COPLEY TOWNSHIP ARCHITECTURAL REVIEW BOARD

September 10, 2018

Applicant: Justus Snow, Pastor
Business Name: Crusade Baptist Church
Landowner: Crusade Baptist Church
Property Address: 2982 Copley Road
Property Location: Parcel 1500716
Zoning District: R-MD
 (Residential-Medium Density)
Proposal: Site Plan for Pavilion and Accessory Buildings

Applicant: Kevin O'Malia-Mann Parsons Gray Architects, Inc.
Business Name: Omni Property Companies, LLC
Landowner: Omni Heritage Center LLC/OCG Copley Land LLC
Property Address: Heritage Center Drive
Property Location: Parcel(s): 1702655, 1702047, 1702656
Zoning District: Planned Development District (PDD)
Proposal: Site Plan for Senior Living Villas

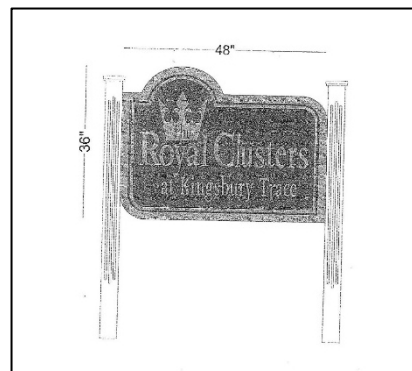
Ms. Gfroerer stated that the applicant is requesting two (2) identification signs at 3' x 4' for a total of 12 square feet per identification sign. The signs will be comprised of wood and plastic and non-illuminated. Ms. Gfroerer stated that the Department of Community & Economic Development recommends approval of the signs with written approval from Ms. Hummel to place the sign on her property. Ms. Gfroerer stated that the sign is compatible and complimentary with the surrounding neighborhood.

Mr. Groll asked if there was a sign on her property now. Ms. Scott said that there is a small metal sign on the pole and those will be removed once they place the new signs.

Mr. Gregory moved to approve the two subdivision identification signs with the condition that Ms. Hummel gives written permission and the old signs are removed. Mr. Groll second. Mr. Gregory called for the vote. Motion carried.

POLE SIGN-REPLACE WITH GROUND SIGN

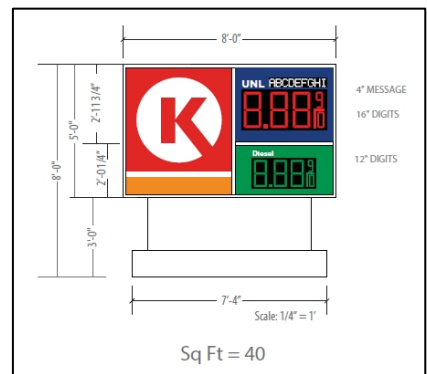
The existing pole sign will be removed and replaced with a ground sign.

The sign will be comprised of back-lit pan formed panels, LED price digits and internally illuminated LED.

Ms. McPherson asked if the base of the sign was metal. Ms. Gfroerer stated that yes, it appeared to be some type of flat surface. Ms. Gfroerer stated that they recommend it be some type of brick or brick façade to match the brick on the buildings.

RECOMMENDATION: APPROVAL with condition of brick foundation compatible with existing building brick.

AWING SIGN

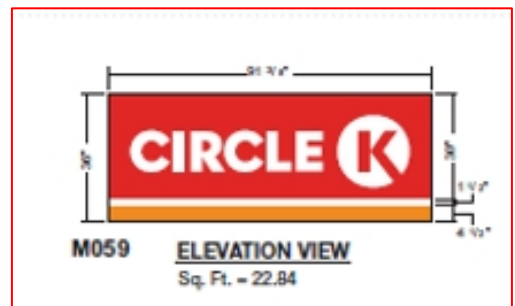
*The applicant is permitted 105 square feet based on a building frontage of 70’ for both building sign 1 and the awning sign. The combined total requested is 30.4.

The sign will be an internally illuminated box sign.

RECOMMENDATION: APPROVAL

Building Sign 1-REFACE

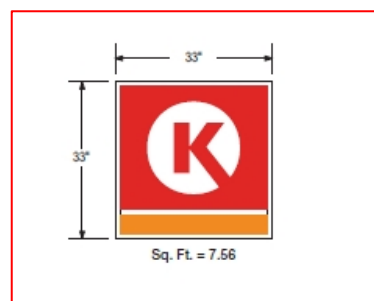
EXISTING: 7.56 square feet

The signs will be refaced with a new cabinet panel and internally illuminated.

RECOMMENDATION: APPROVAL

POLE SIGN-REPLACED WITH GROUND SIGN

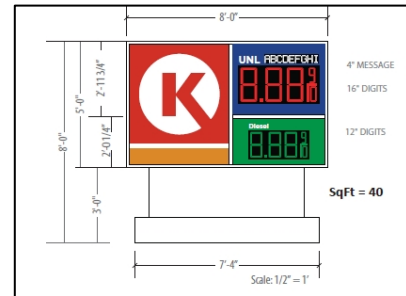
The existing pole sign is 25' in overall height and 71.75 square feet. The proposed ground sign will be 40 sq. ft. and 8' in overall height and 10' from road right of way.

The sign will be internally illuminated LED.

RECOMMENDATION: Approval with the following conditions- consider alternative location for sign and add brick foundation compatible with existing building brick.
